Service Information

Category F	Repair Guidance	Ref. No. R012/14A	Page 1 of 6
Coverage <input type="checkbox"/> Distributor only <input checked="" type="checkbox"/> Please inform your dealers		Date Issued January 23, 2014	
Please convey this information to your <input type="checkbox"/> Director <input checked="" type="checkbox"/> General Manager <input checked="" type="checkbox"/> Warranty Dept. <input checked="" type="checkbox"/> Parts Dept. <input checked="" type="checkbox"/> Training Dept. <input checked="" type="checkbox"/> Field Rep.		Date Revised February 4, 2014	
Applicable Model Mazda3 (BM), Mazda6 (GJ), CX-5 (KE) with SKYACTIV Engine & i-ELOOP		Applicable Countries or Specifications Worldwide (Except North America)

REVISED

Subject: i-Stop Warning Light flashing, Master Warning Light & Charging System Warning Light illumination and a message "Charging System Malfunction/Engine could stop unexpectedly" in LCD (DTC P1794 and P2502)

Start Stop switch light flashes.

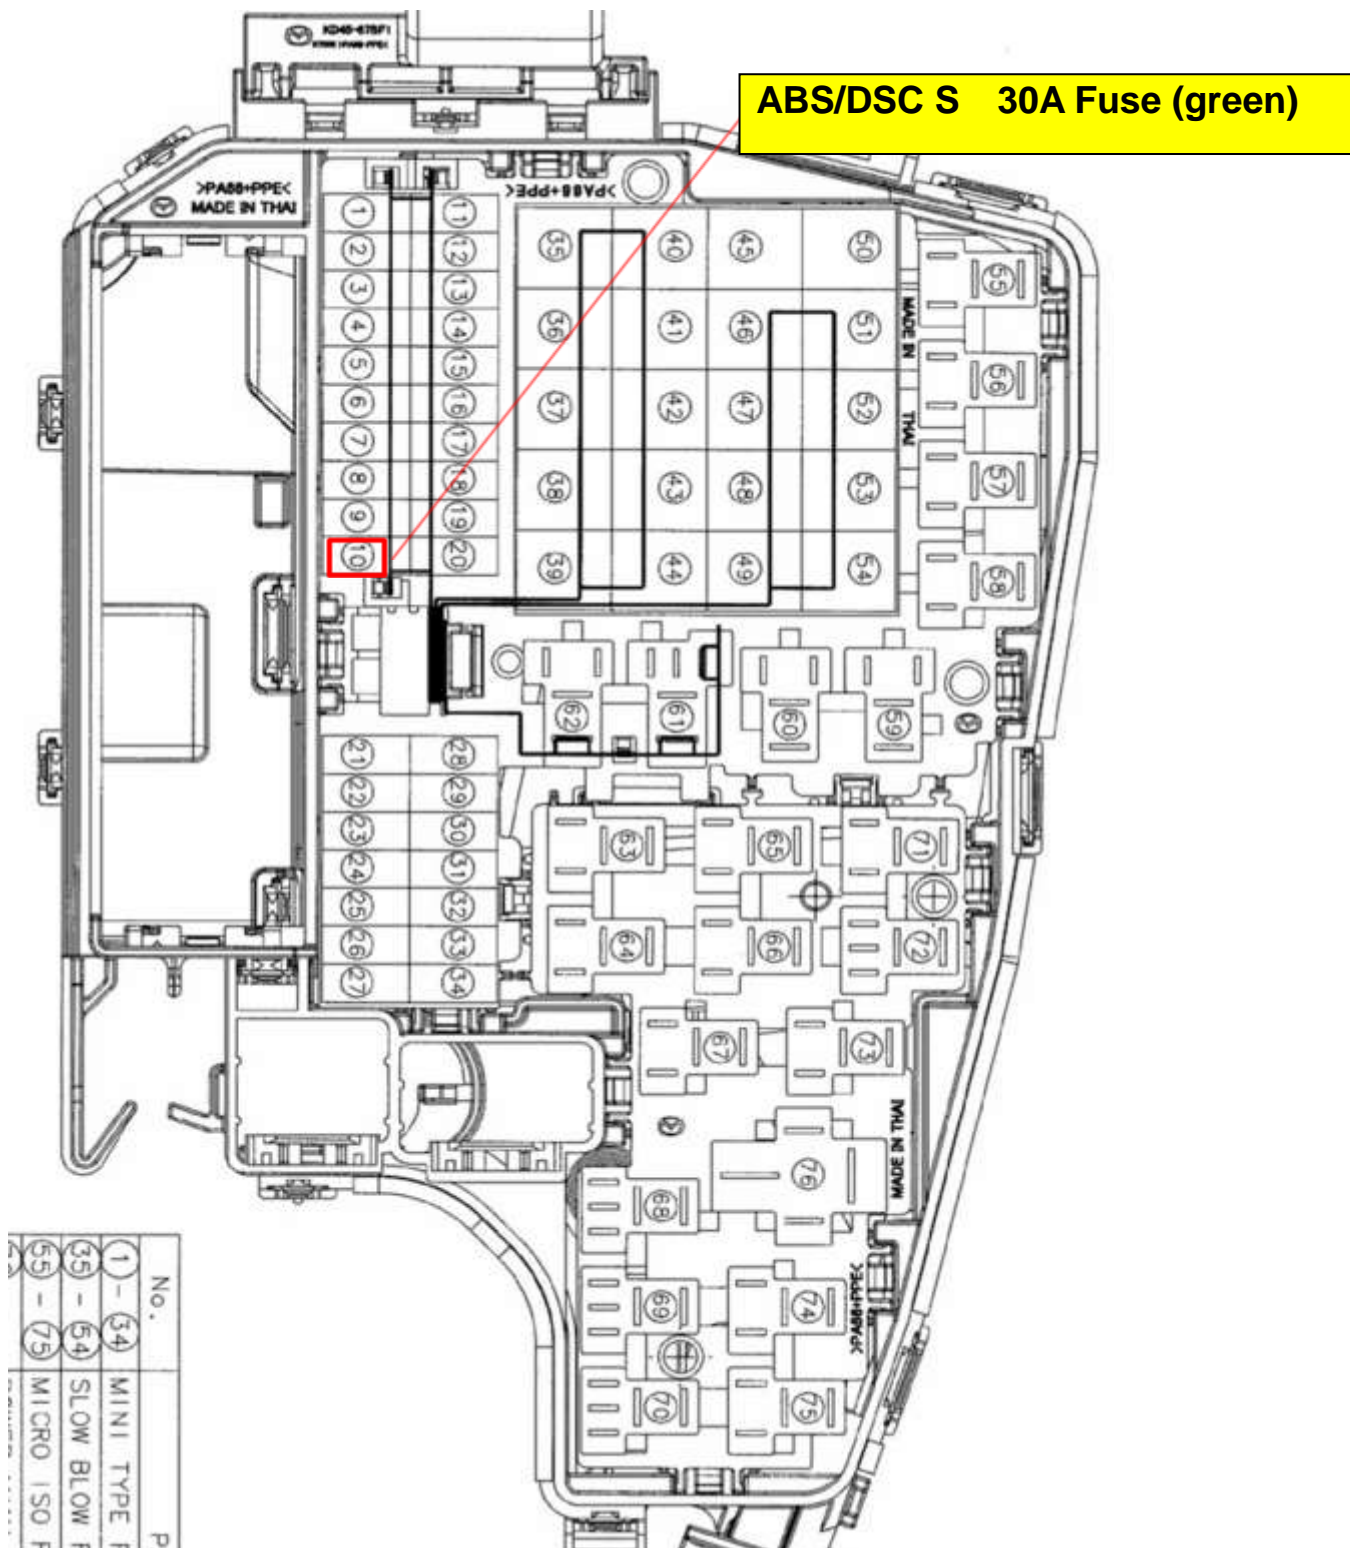
Note: During PCM reprogramming, some vehicles may show some warning messages with flashing Start stop switch. This is caused by reset function of ABS/DSC CU not working properly.

Below warning messages are displayed.

1. After PCM reprogramming has been finished, turn the IG-off by pushing Start Stop switch for long time (around 3 seconds) to turn off.
2. After that, disconnect **ABS/DSC S 30A** Fuse for 30 seconds so that the system is reset back to normal.

Note: There is a similar named fuse "ABS/DSC M 50A. Be sure to avoid confusion.
